MORGAN SHEET METAL ADDITION

Re: S/D 96-59 Final Plat of the MORGAN SHEET METAL ADDITION

STAFF REPORT
(Final Plat Approved 9/5/96)

CASE NUMBER: S/D 96-59 - MORGAN SHEET METAL ADDITION
OWNER/APPLICANT: Morgan Sheet Metal, Inc., 4350 Southeast Boulevard, Wichita, KS 67210
SURVEYOR/ENGINEER: Attn: Mark Savoy, Savoy, Ruggles, & Bohm, P.A., 924 N. Main, Wichita, KS 67203

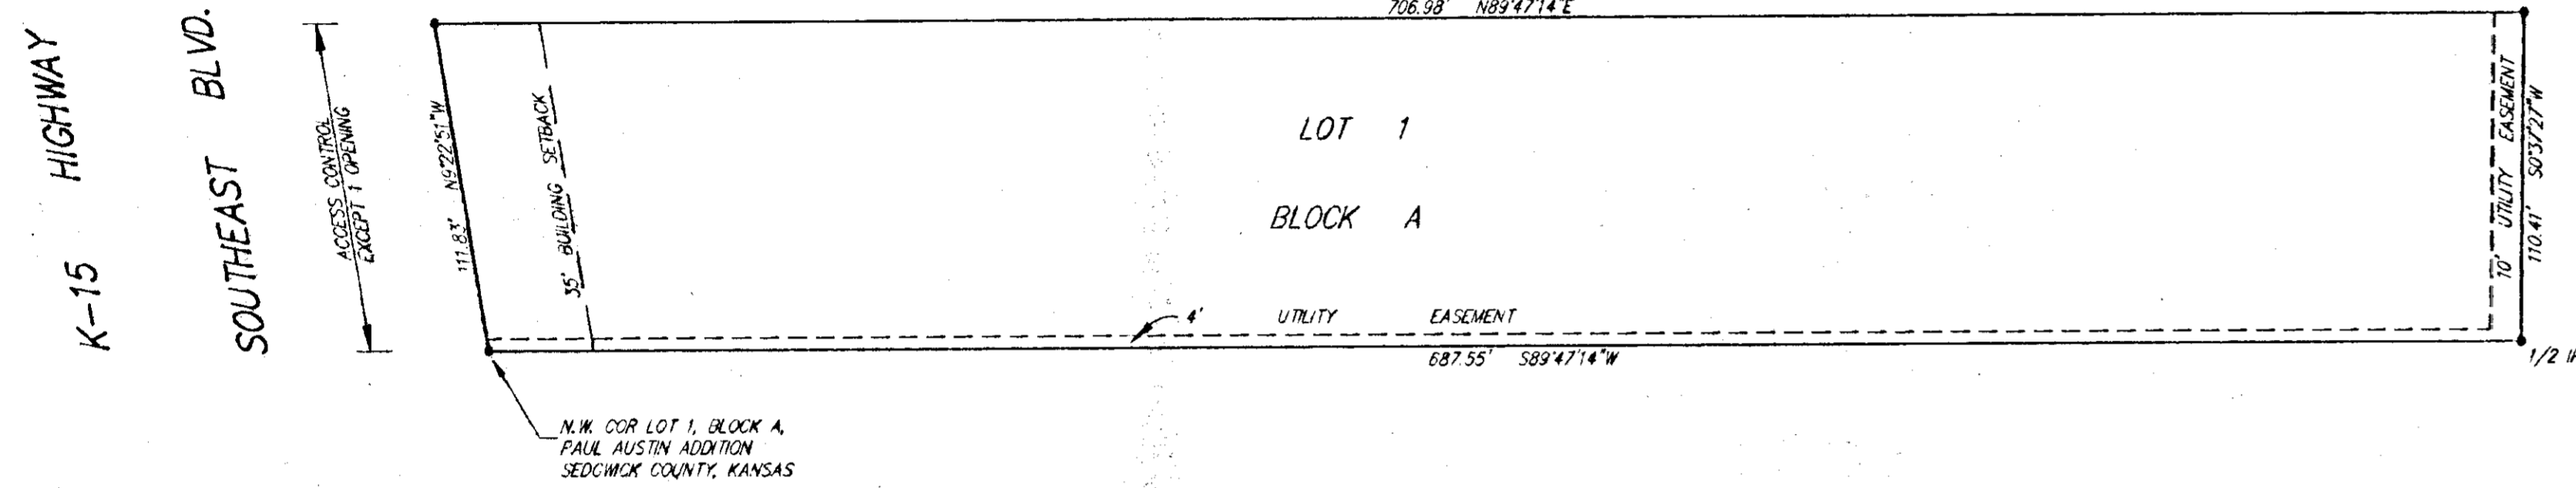
- A. Prior to this plat being scheduled for City Council review, the applicant shall submit a letter from Oaklawn indicating that arrangements have been made for this site to connect to the Oaklawn sanitary sewer system.

- B. The applicant shall guarantee any drainage improvements required by the platting of this property.
- C. If improvements are guaranteed by petition, a notarized certificate listing the petitions shall be submitted to the Planning Department for recording.

- D. The final plat tracing shall indicate the platting of the 35-foot building setback from K-15 through the existing building which encroaches into the setback area. While the platting of this building setback does not preclude the property owner from maintaining or remodeling that portion of the building within the setback area. The building cannot, however, be enlarged within the setback and, if the building is removed, any new building construction must observe the platted building setback.

- E. The final plat shall reference a tie point to a previously platted lot corner or section corner.
- F. On the final plat tracing, the legal description shall be corrected to note "the south 110.4 feet..." (not fet).

- G. The applicant shall submit an avigational easement covering all of subject plat and a restrictive covenant assuring that adequate construction methods will be used to minimize

the effects of noise pollution in the habitable structures constructed on subject property.

- H.* The applicant shall install or guarantee the installation of all utilities and facilities which are applicable and described in Article 8 of the MAPC Subdivision Regulations. (Water service and fire hydrants required by Article 8 for fire protection shall be as per the direction and approval of the Chief of the Fire Department.)
- I.* The applicant's engineer is advised that the Register of Deeds is requiring the name(s) of the notary public, who acknowledges the signatures on this plat, to be printed beneath the notary's signature.
- J.* Perimeter closure computations shall be submitted with the final plat tracing. Section 5-101(c).
- K.* Recording of the plat within 30 days after approval by the City Council and/or County Commission.
